CITY OF FORT LAUDERDALE

# DEVELOPMENT REVIEW COMMITTEE

## CASE COMMENT REPORT

<b>CASE</b>	UDP-S25045
<b>PROJECT NAME</b>	811 E Las Olas
<b>APPLICATION TYPE</b>	Site Plan Level III
<b>APPROVAL LEVEL</b>	Planning and Zoning Board
<b>REQUEST</b>	16,167-Square Feet Commercial Use with Associated Parking Reduction Request
<b>APPLICANT</b>	Coombes Properties, Inc.
<b>AGENT</b>	Robert B. Lochrie III, Esq. and Nectaria M. Chakas, Esq. Lochrie & Chakas, P.A.
<b>PROPERTY ADDRESS</b>	811 E. Las Olas Boulevard
<b>ABBREVIATED LEGAL DESCRIPTION</b>	Colee Hammock 1-17B Lot 11 BLK 9
<b>ZONING DISTRICT</b>	Regional Activity Center – East Mixed Use (RAC-EMU) and Boulevard Commercial (B-1)
<b>LAND USE</b>	Downtown Regional Activity Center and Commercial
<b>COMMISSION DISTRICT</b>	4 – Ben Sorensen
<b>NEIGHBORHOOD ASSOCIATION</b>	Beverly Heights Association,
<b>SUBMITTED</b>	October 24, 2025
<b>COMPLETENESS ISSUED</b>	October 31, 2025
<b>STATE STATUTE 166.033 EXPIRATION</b>	May 6, 2026 (180 Days)
<b>CASE PLANNER</b>	Lorraine Tappen, AICP, Principal Urban Planner

#### **Storefronts**

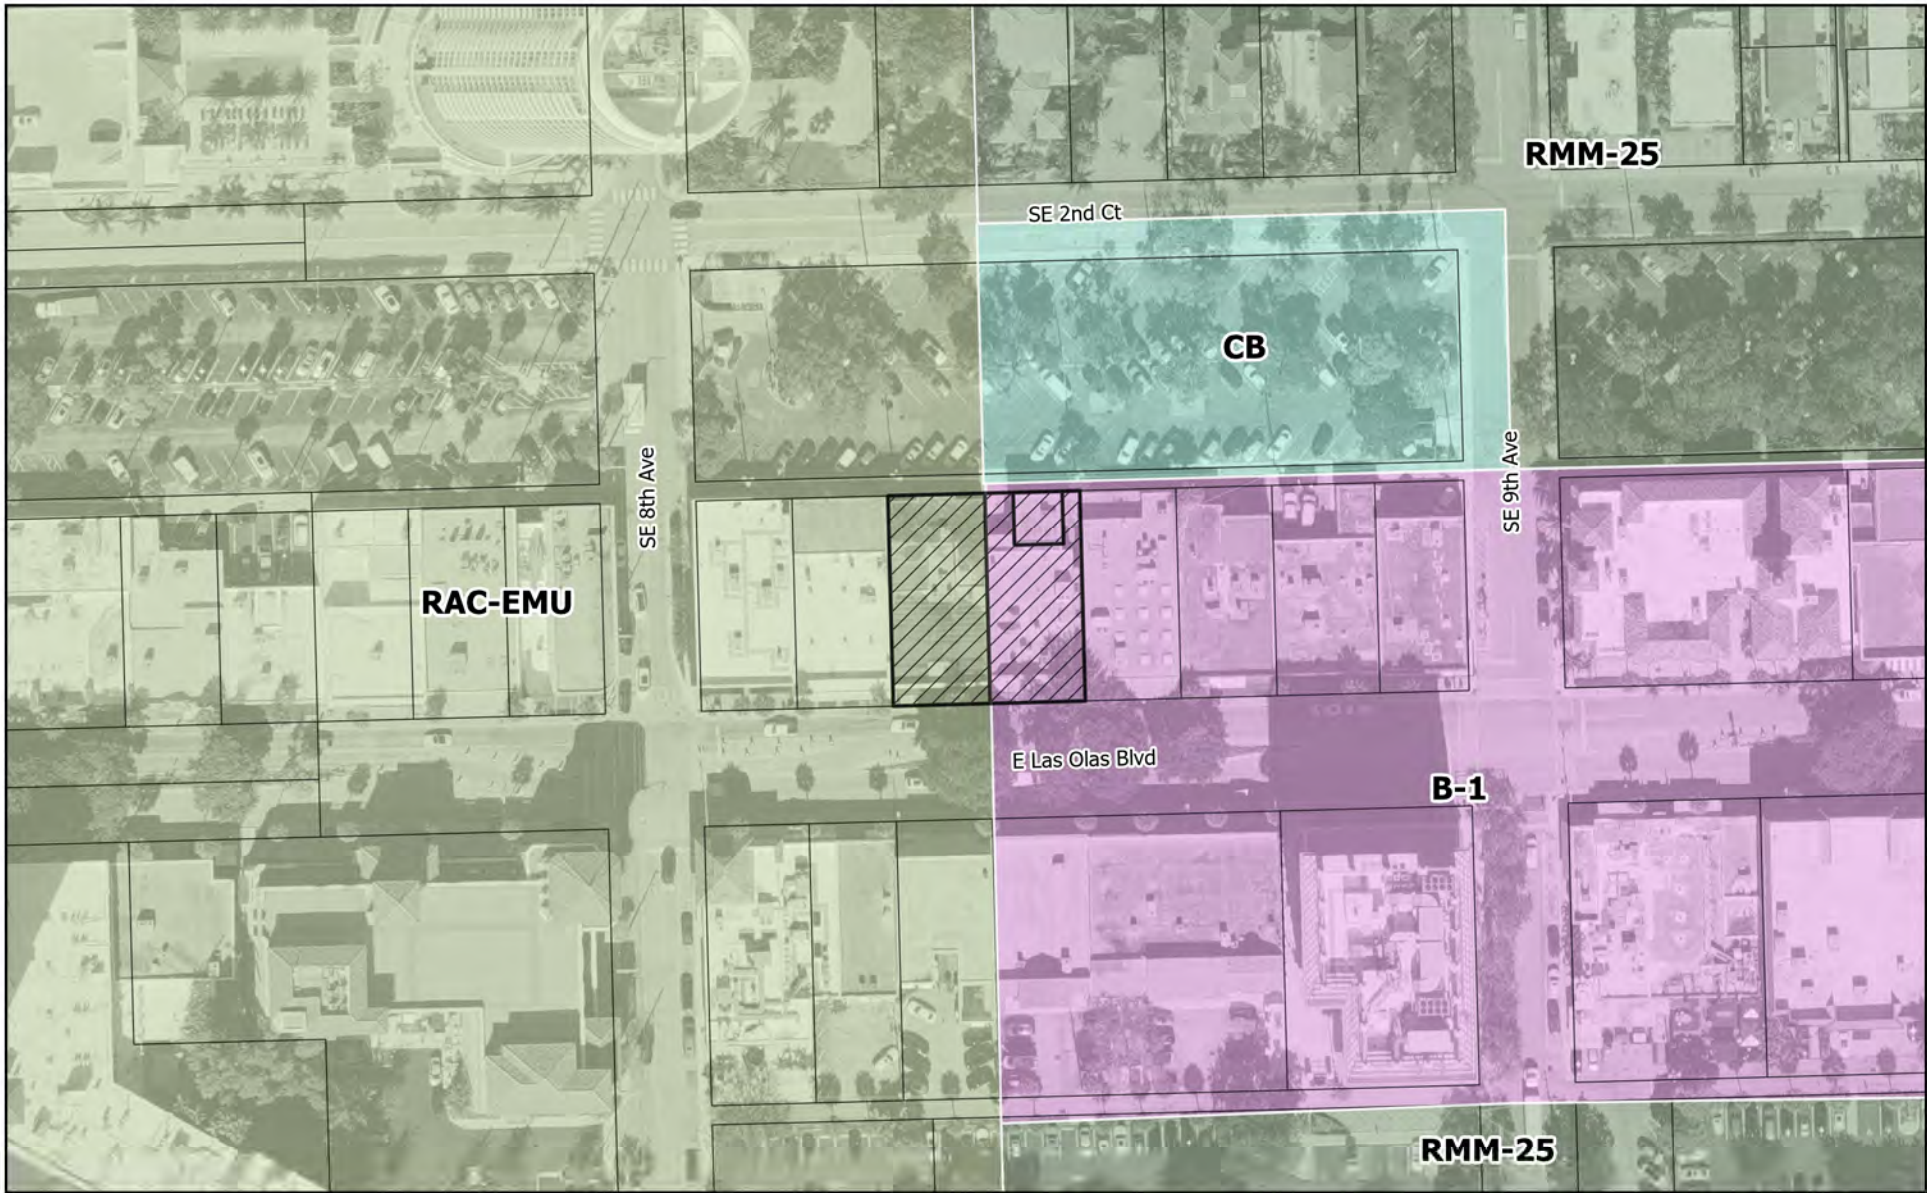
- a. SF6. Pedestrian shading devices. Consider adding eyebrows that can provide pedestrian shading.
10. Clarify the following:
    - a. If property boundary on Sheet SP-101 is correct.
